DEVELOPMENT REVIEW COMMITTEE (DRC) COMMENT REPORT

PROJECT NAME: 1023 Apartments

CASE NUMBER: UDP-PRE21004

REQUEST: Preliminary Site Plan Level II Review: 6 Multifamily
Residential Units

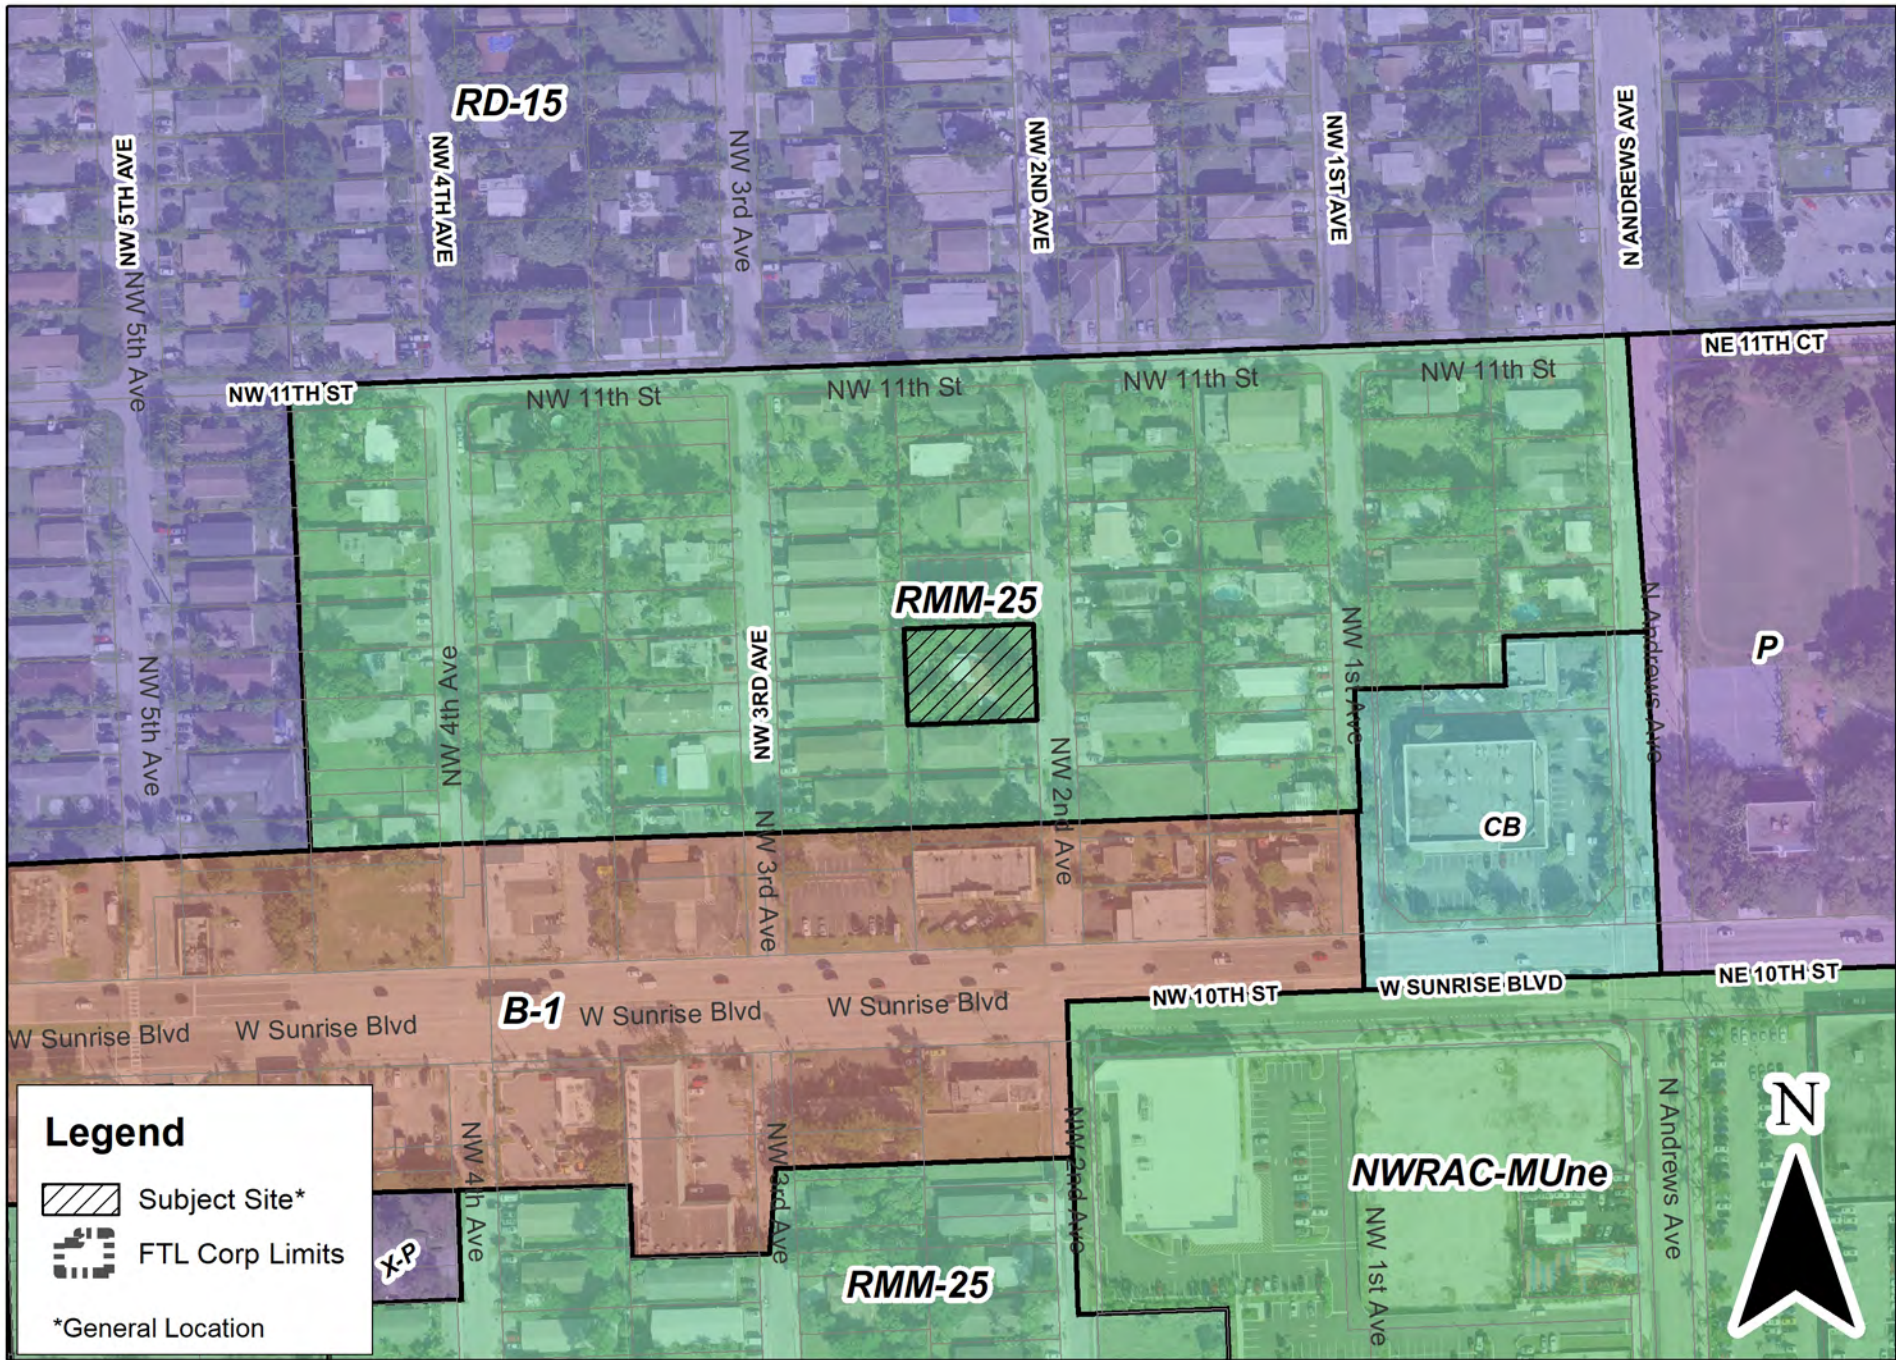
- 9) Pursuant to ULDR Section 47-19.2.Z, Accessory Uses, Buildings, and Structures; rooftop mechanical equipment such as air conditioners, compressors, generators, etc. shall be screened with material that

- matches the material used for the principal structure and shall be at least six (6) inches high above the top most surface of the roof mounted structures. Provide the following:

- a. Roof plan indicating the location of all mechanical equipment with spot elevations of the parapet wall and roof as well as mechanical equipment to verify adequate screening;

- b. Identify the location of equipment on building elevations by outlining the equipment with dash lines; and
 - c. Provide screening product material including images or pictures of actual application of such.
